**CONDITIONAL APPROVAL
PLAN APPROVAL EXPIRES: 03/18/2017**

Christian Education Leadership Academy
W262N4685 Ryan St
City of Pewaukee, 53072
Waukesha County

Facility: 739041 CHRISTIAN EDUCATION LEADERSHIP ACADEMY
W262N4685 RYAN ST
PEWAUKEE 53072
Plan Type: New; 1 Interior Fixture(s)

Object Type: Commercial Water Treatment Device Regulated Object ID No.: 1528450

H300-300-30 TRIPLEX DEMAND RECALL	
DWG #	73-H300-300-30 -TR1-DK
4-29-13	
dwg by:	Waunakee, WI 53597
JWAACK	(608)849-3050
Approved by	A. MAST
Engineer:

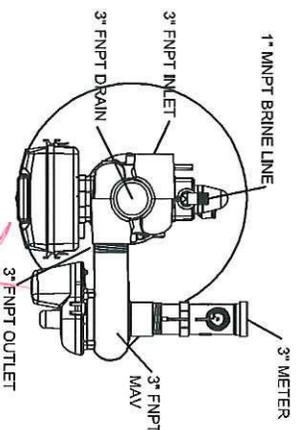
- Flow controls shall be installed to prevent the softeners from exceeding their maximum rated service flow rates.
- Any wall hydrants, or other potable water fixtures designed for consumptive use, must have at least one of the following:
 1. The handles of the hydrant shall be removed;
 2. The hydrant shall be capped and sealed using solder; or
 3. Signage shall be posted immediately above the hydrant of fixture indicating the water is unfit for human consumption.
- All piping shall be labeled in accordance with Table SPS 382.40-1a.
- No bypass piping shall be installed serving these devices.

If a bypass is strongly desired, then it must be of the locking type.
